#### GENOA CHARTER TOWNSHIP BOARD Regular Meeting and Public Hearing May 4, 2015

**Environmental Impact Assessment & Site Plan**

I have reviewed the proposed rezoning, PUD agreement amendment, revised environmental impact assessment and revised site plan for a proposed 3,848 sq. ft. Red Olive Restaurant, located at 3838 E. Grand River Avenue, Howell, on parcel #4711-05-400-025.

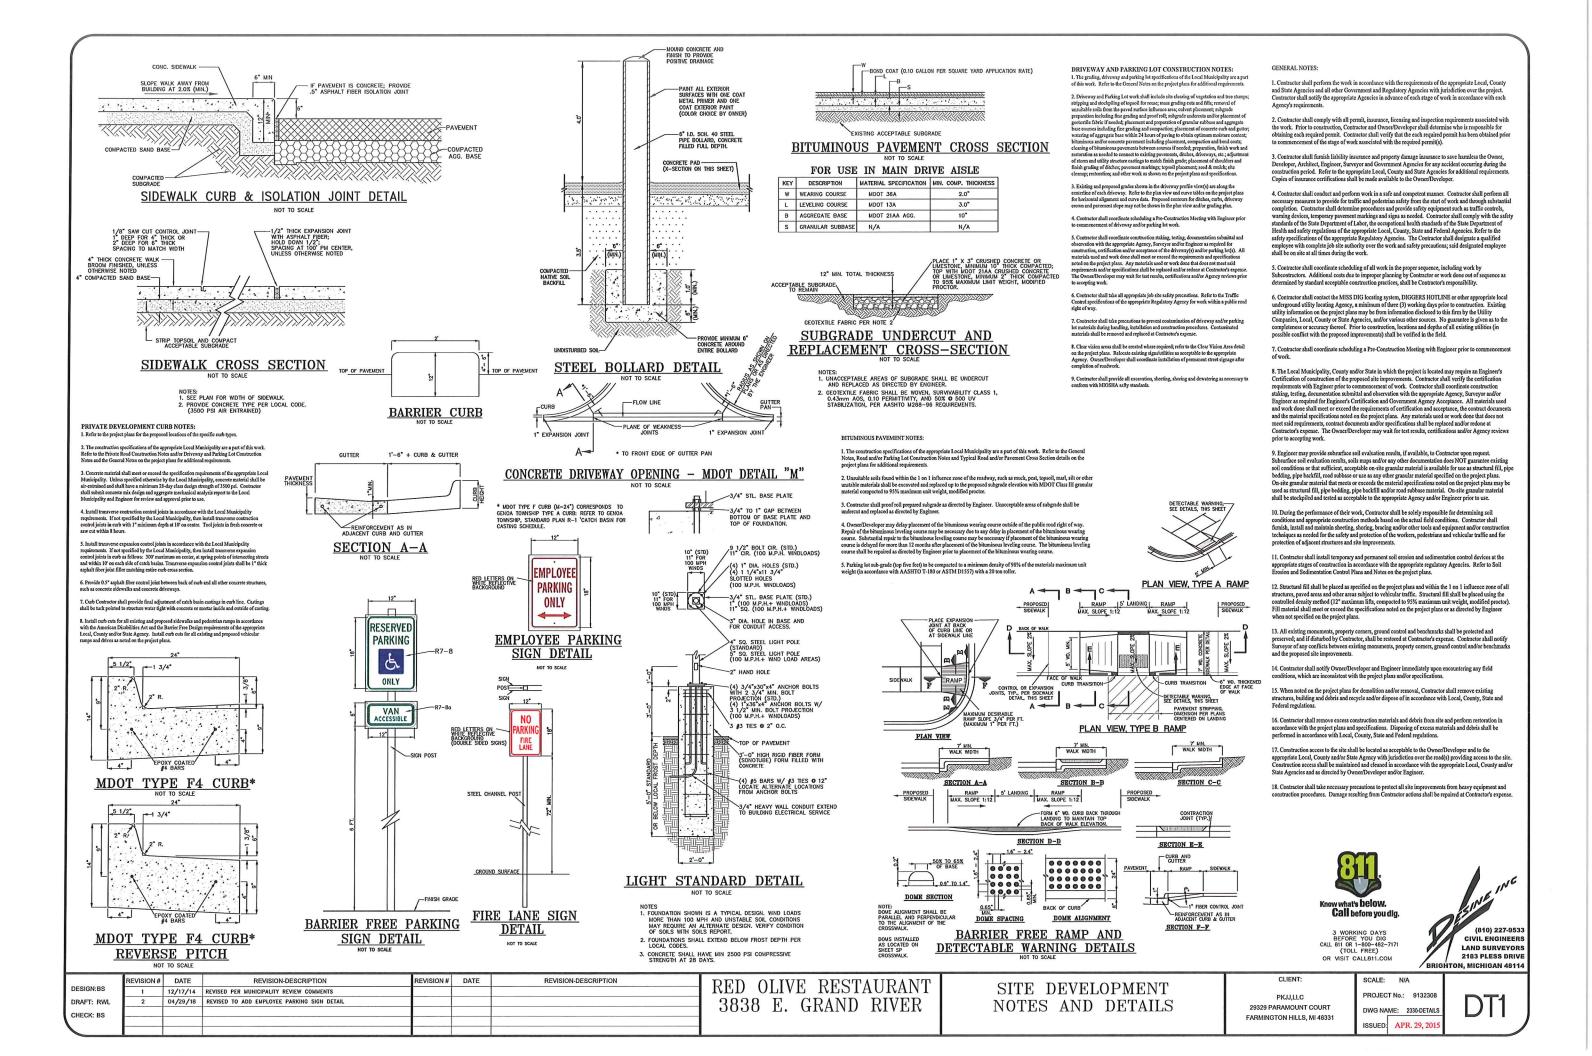
**6. Exterior Lighting.** The submittal includes a lighting plan (Sheet LT1), which proposes the installation of 5 light poles along the driveway and within the parking lot, as well as 16 wall mounted fixtures. The photometric readings are rather modest (3.8 footcandle maximum) and well within that allowed by Ordinance.

Fixture/pole details on Sheet LT2 identify the use of an ornamental light pole/fixture at the site entry, as well as downward directed, cut-off pole and wall mounted fixtures.

C - 3.1

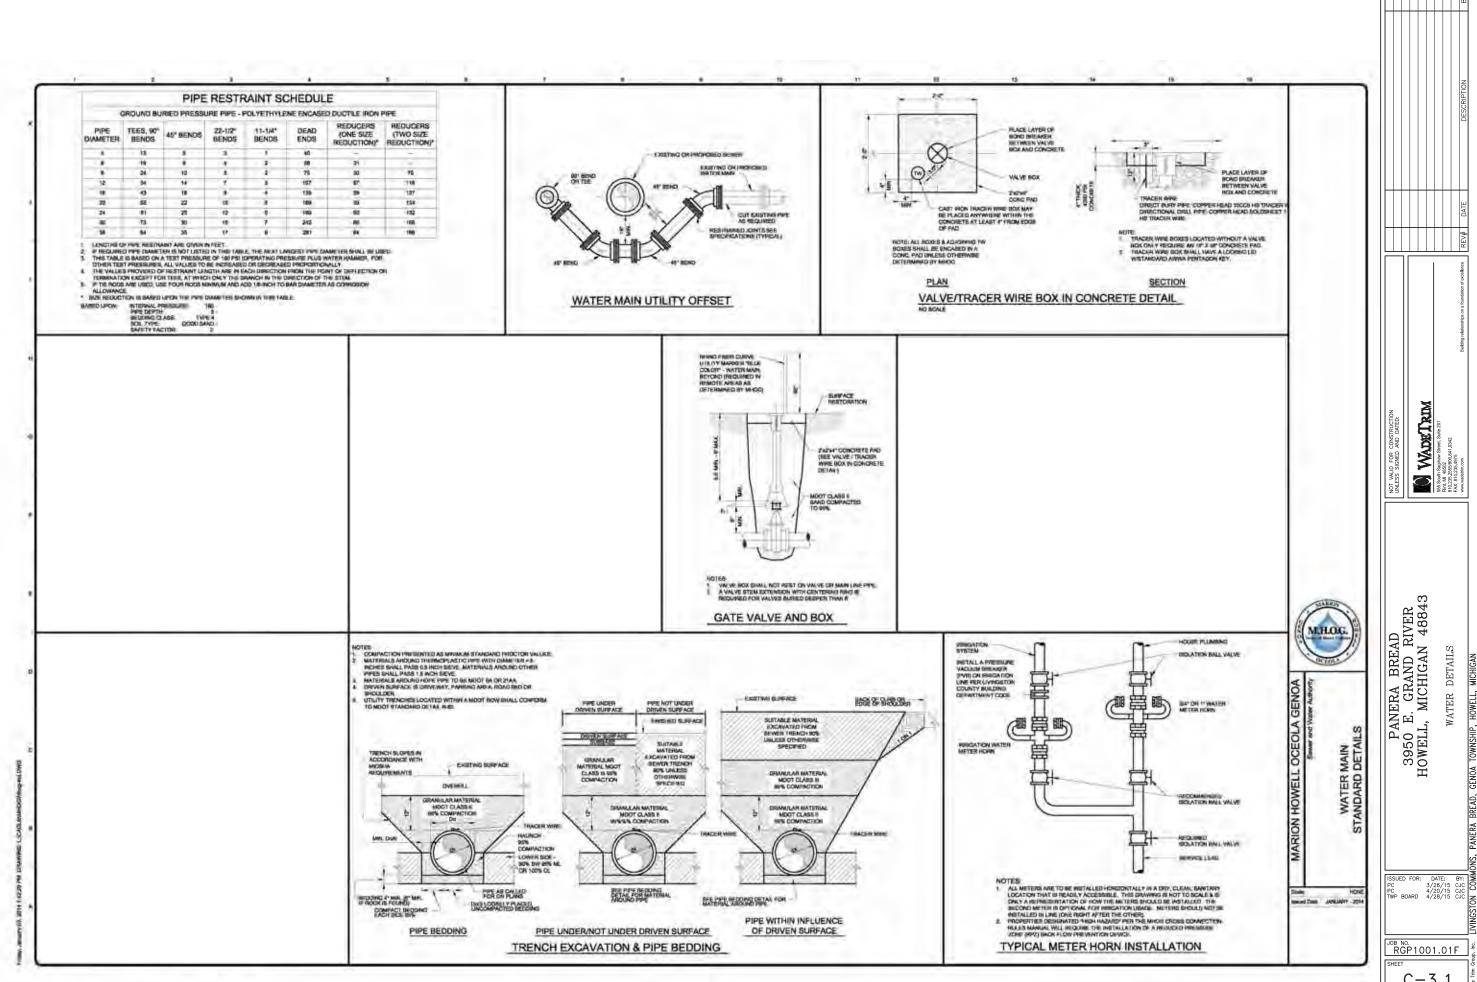
- 1. The petitioner is showing measures taken to extend a 6-inch sanitary service lateral west of the proposed manhole to accommodate future connection. Please indicate on the drawings the location of where the water service lead for the future restaurant is most likely to be installed.
- 2. For the construction plans, make sure all old notes that no longer apply are completely removed. A note regarding hydrant construction and pavement restoration is still included near the top of the page on sheet C-3.0.

SITE LIGHTING POLE DETAIL

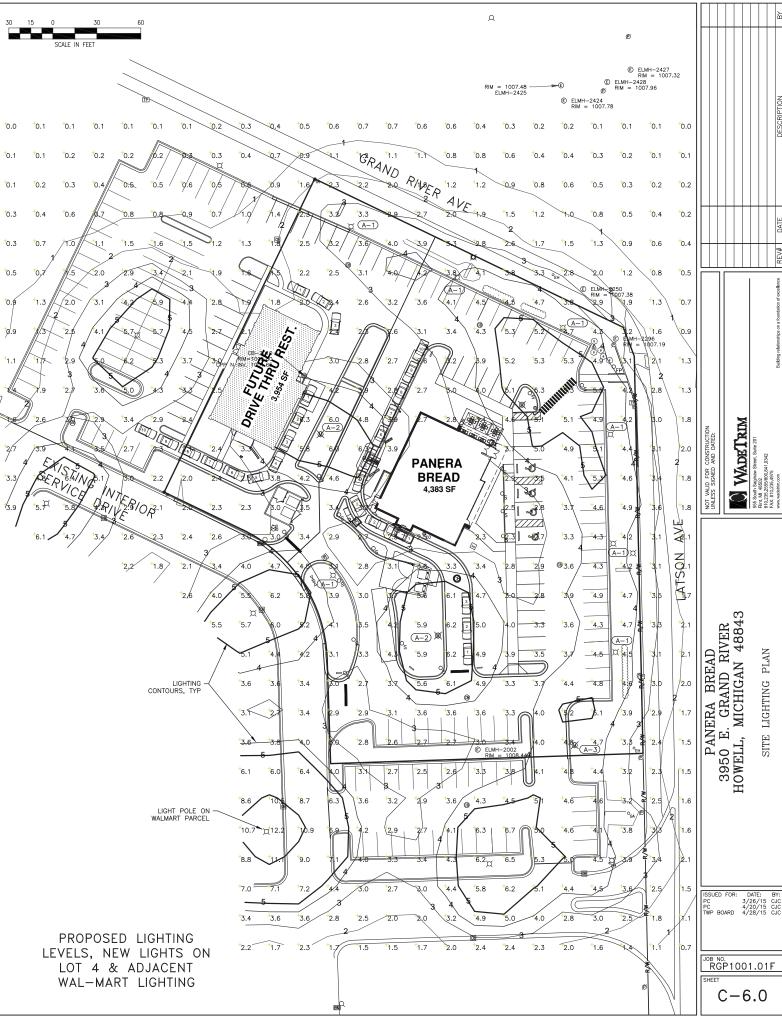
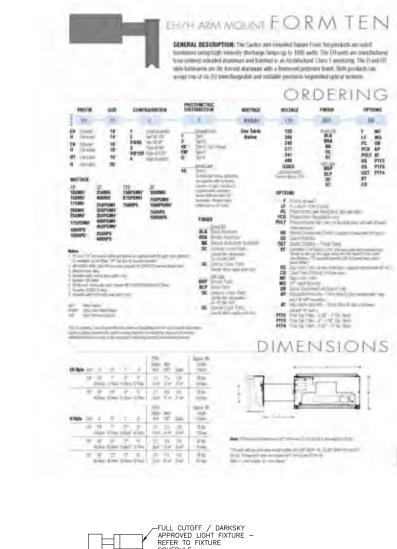
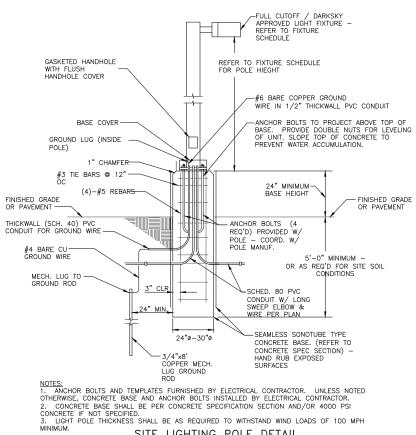
**9. Exterior Lighting.** The submittal includes a lighting plan (Sheet C-6.0), which proposes the installation of 4 new light poles and 7 new light fixtures on existing poles. The table identifies 3 different types (A-1, A-2 and A-3), although there is no indication of any wall mounted fixtures.
